## **Service Bulletin**

**No. :** MZ03-058

**Model:** CC4300, PMD371

**Subject:** DIGITAL Output (OPTICAL) jack was changed.

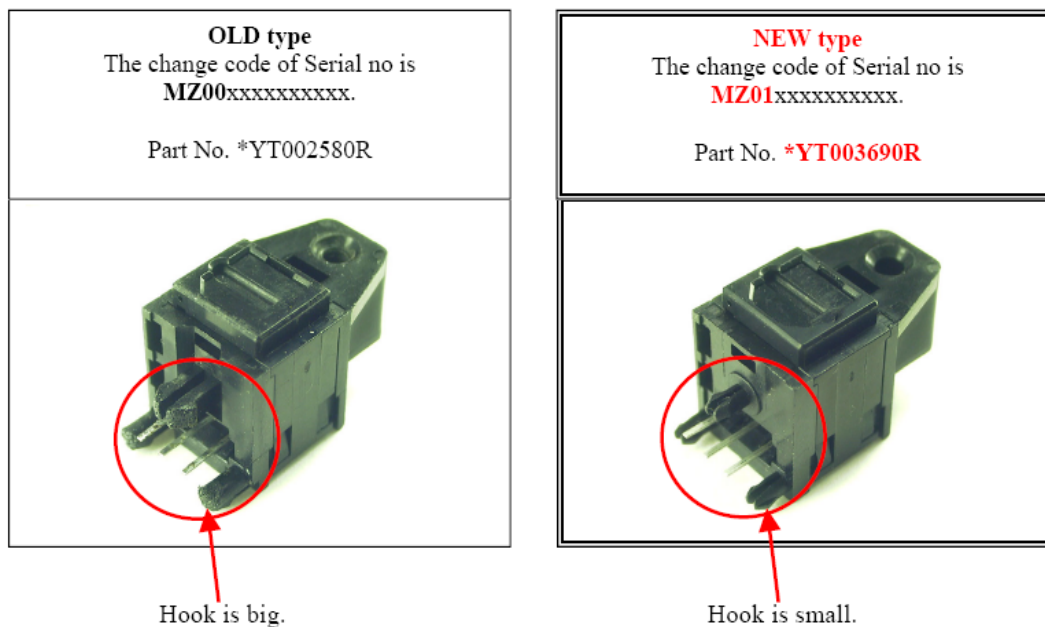
**Symptom:** The OPTICAL jack was changed by manufacturer.

**Solution:** 1) The OLD and NEW type are compatible in performance, but you cannot replace the OLD type with NEW type. (The PCB mounting hole dimension is different.)

2) The NEW type can be replaced with the OLD type.
